ENVIRONMENTAL REVIEW TEAM REPORT

HARWINTON WOODS SUBDIVISION

HARWINTON, CONNECTICUT

NOVEMBER 1978

SIMPLIFIED SITE PLAN - HARWINTON WOODS

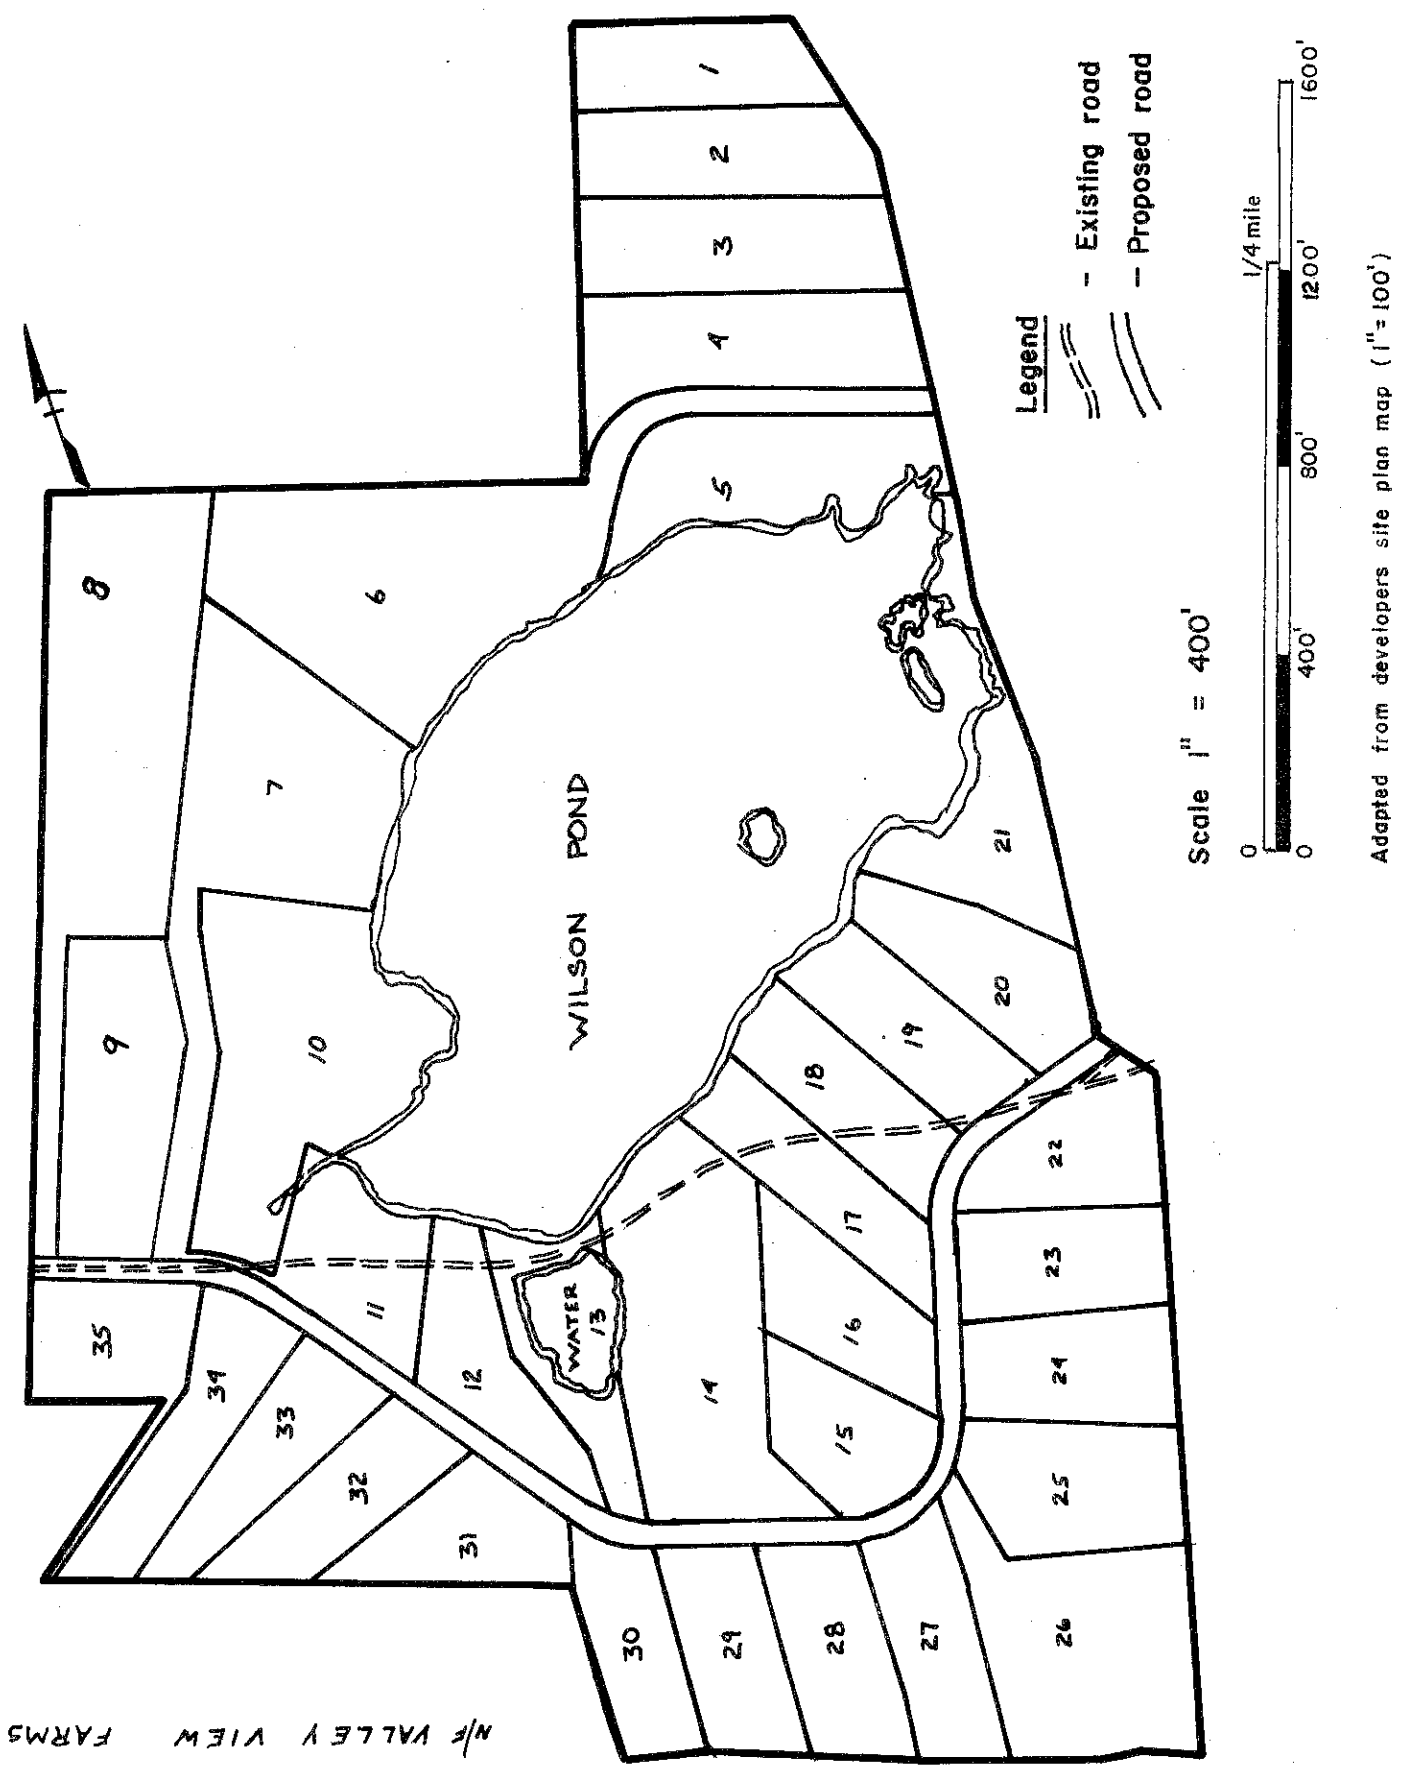
The Town of Harwinton, Connecticut is presently reviewing a subdivision application which calls for 35 lots on 132.7 acres of land. The proposed subdivision, known as "Harwinton Woods", has been submitted by Stanley Lessler and Emil Schipul of Trumbull. The proposed development would create 34 building lots from 2-7 acres in size and one recreation lot of 29.8 acres in size (See Figure 1). The proposed recreation lot, shown as lot 13 in Figure 1, would encompass Wilson Pond, another smaller pond, and \pm 1.5 acres of land. The subdivision would also result in the construction of a new town road and the abandonment of an existing town road (See Figure 1). Proposed lots would be serviced by on-site wells and septic systems.

In general the soils found on this site are favorable for the proposed development as shown in the site development plan. No home construction is shown within the wetland areas. Those areas where wetland crossings are shown for the proposed road are minimal. The crossing in the area of lots 28 and 29 is the most significant area. If this crossing is made as proposed (a permeable road base fill material, plus the proposed culvert, and erosion and sediment control measures during and after construction), the overall effect on Wilson Pond and the associated wetlands should be negligible. The major benefits that the wetlands in this area provide are as sediment traps, as storm water flood control areas, and as wildlife habitat to a limited degree.

The developers have shown discretion in their approach to wetland disturbance. Their intentions to maintain a minimum home site set back from Wilson Pond plus a vegetative barrier are commendable. Also, the proposed road placement back from the water's edge is a positive means of avoiding adverse environmental impacts which could be associated with development of the existing town road.

TOPOGRAPHIC MAP

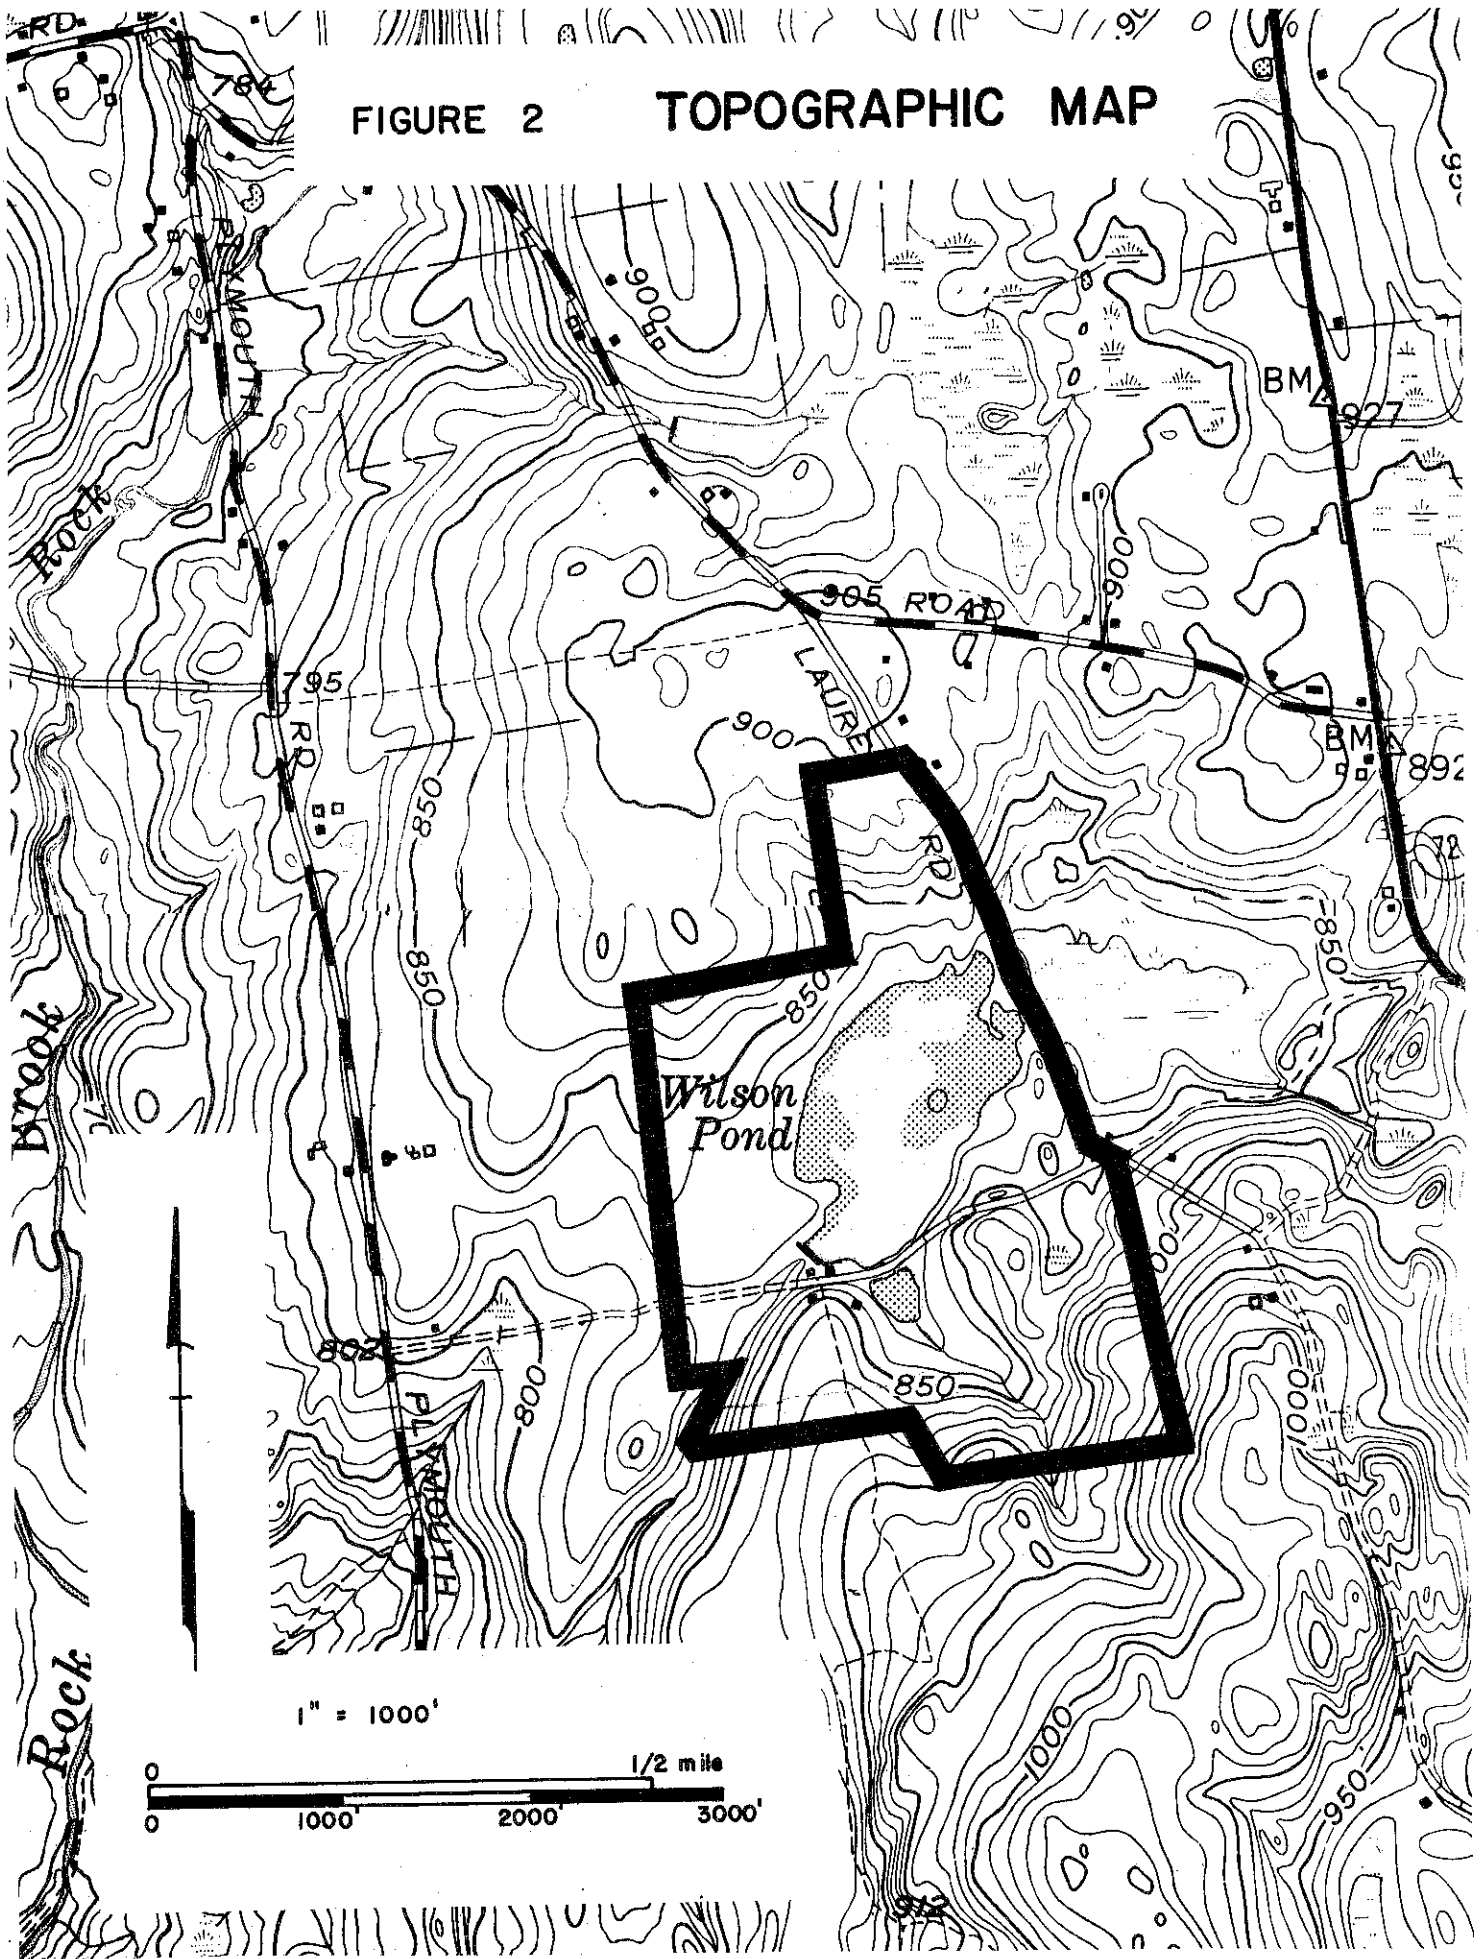
Topography varies throughout the parcel from gently rolling to steeply sloping with most of the property sloping towards Wilson Pond (See Figure 2).

The parcel is predominately forested by mixed hardwoods with a few groves of conifers (hemlock and white pine) interspersed. Historically, the parcel has been in private residential use and a few dilapidated structures are still standing on the property along the old town road south of Wilson Pond (See Figure 2). Planned use of the parcel does not appear to conflict with surrounding land uses.

FIGURE 3 SURFICIAL GEOLOGY MAP

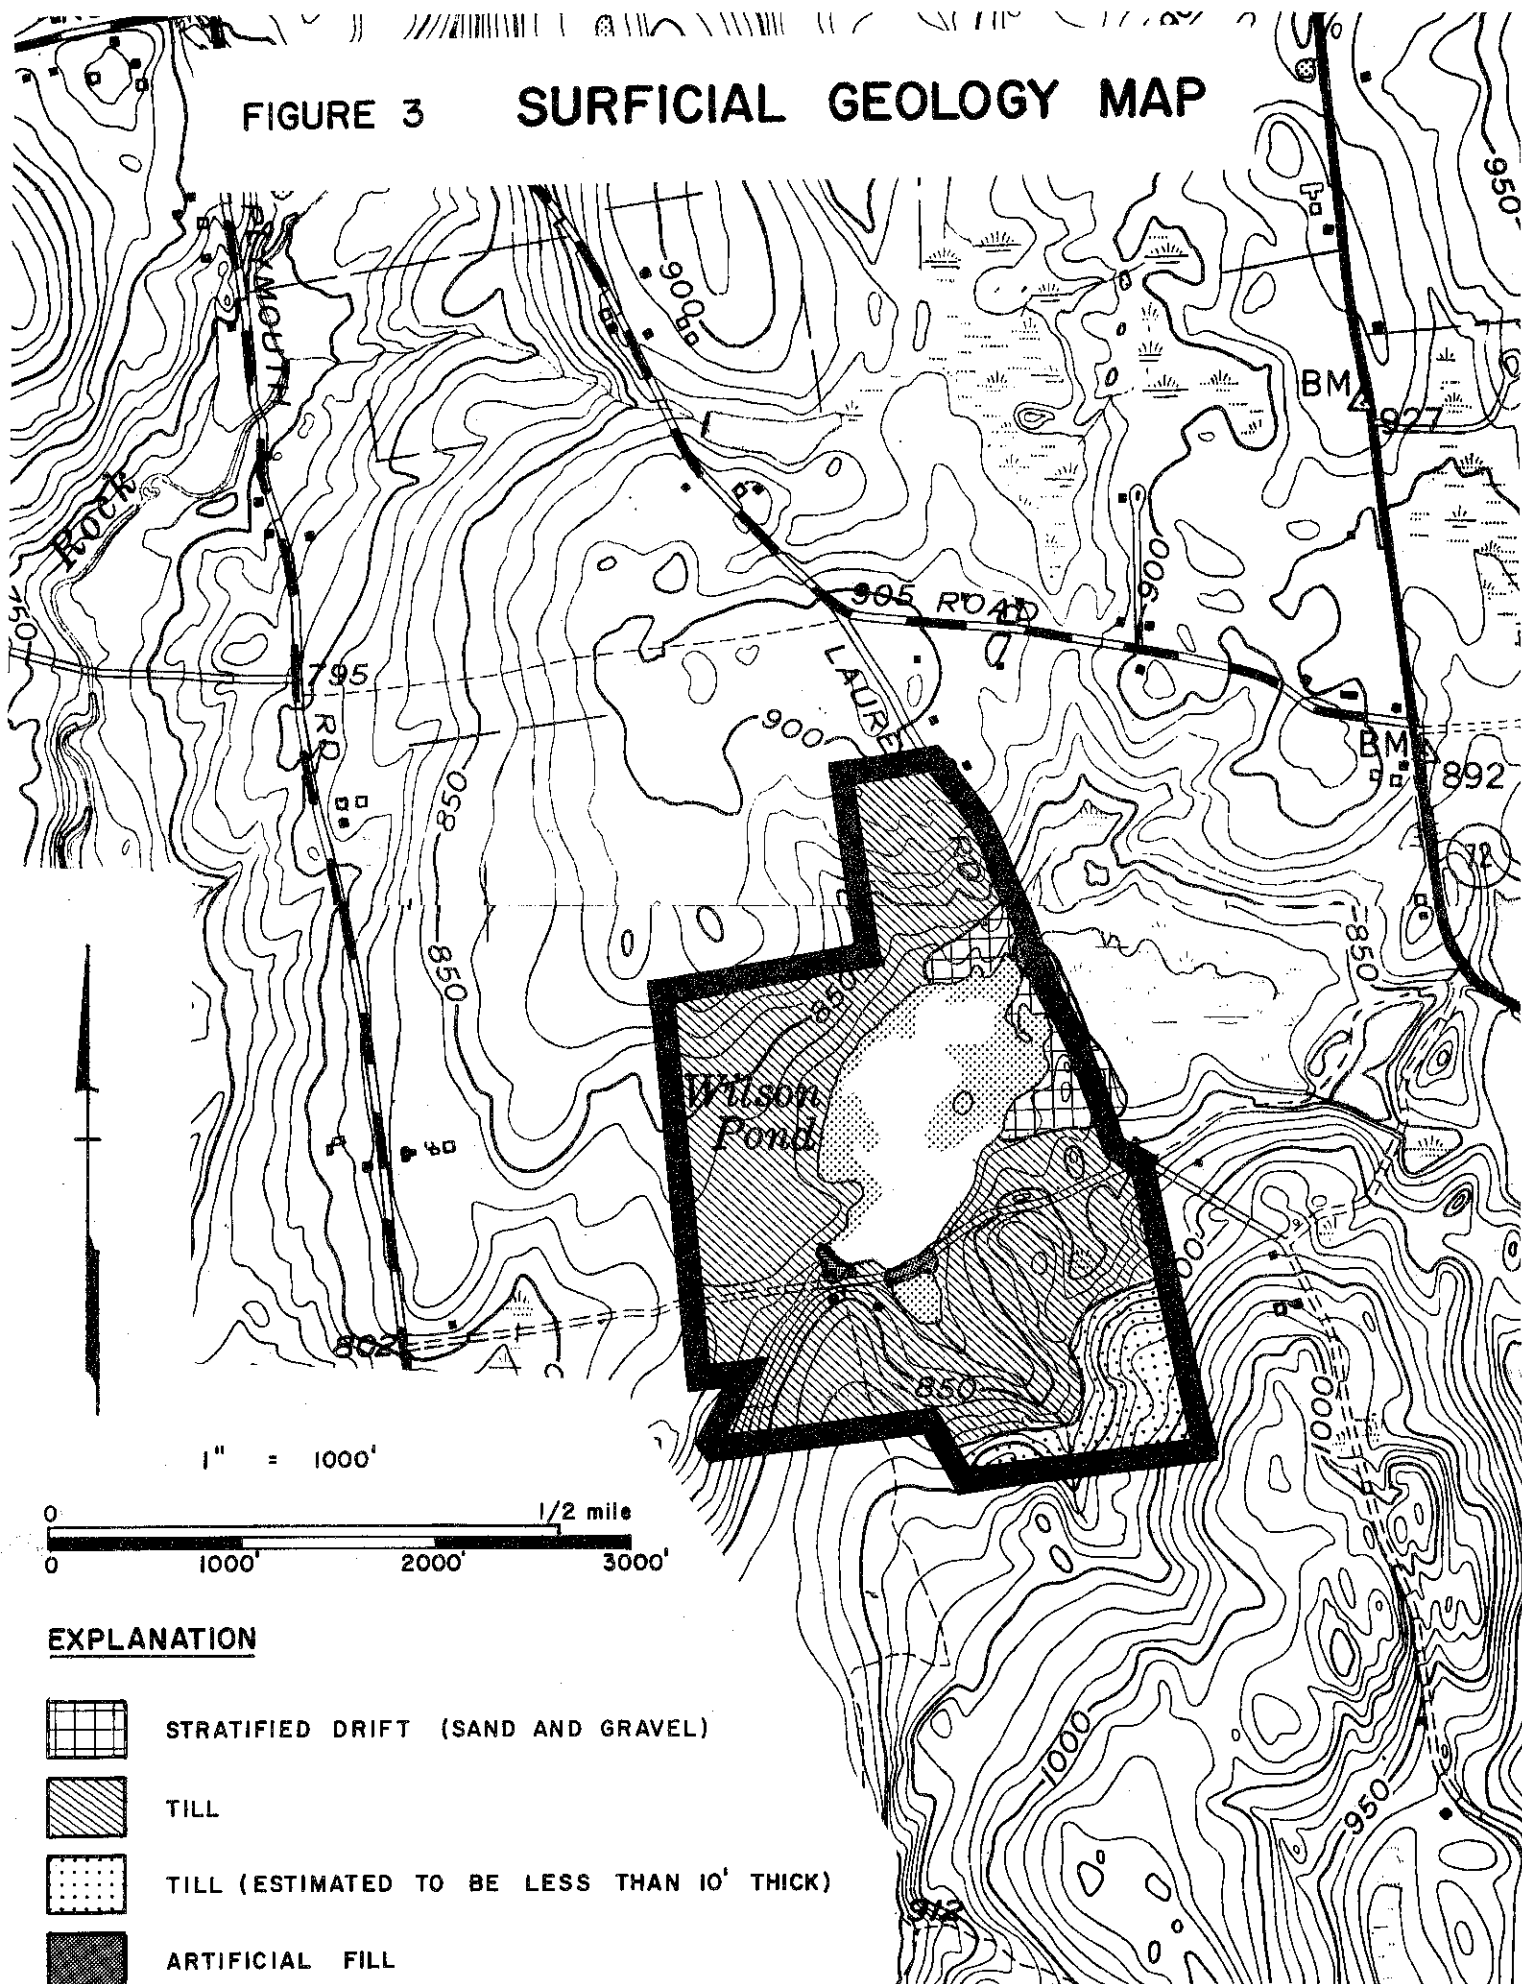
Bedrock underlying Harwinton Woods is part of the Nonewaug Granite, a formation that is mapped and described in The Bedrock Geology of the Torrington Quadrangle,¹ by Charles W. Martin (1970). The granite ranges from fine-grained to very coarse-grained; it may be either layered or massive (nonlayered), and it is typically white or very light-colored. Predominant minerals include plagioclase, microcline, quartz, and muscovite. Accessory or trace minerals include biotite, garnet, apatite, zircon, and magnetite. Numerous boulders, some extremely large, are scattered about the property. No actual bedrock outcrops were observed, although steep topography and concentrations of very large boulders in the southeastern corner of the site suggest that bedrock is generally within ten feet of the surface in that section (See Figure 3). Elsewhere, the bedrock is presumed to be deeper than ten feet.

Surficial geologic maps of the Thomaston and Torrington quadrangles,² by Charles R. Warren (1972) and Roger B. Colton (1971), respectively, include general information on the Harwinton Woods area. A map of the property itself, slightly modified from the published sources, is shown in figure 3. Field investigation suggested that the distribution of stratified drift, which is described below, is not as widespread as the published maps indicate.
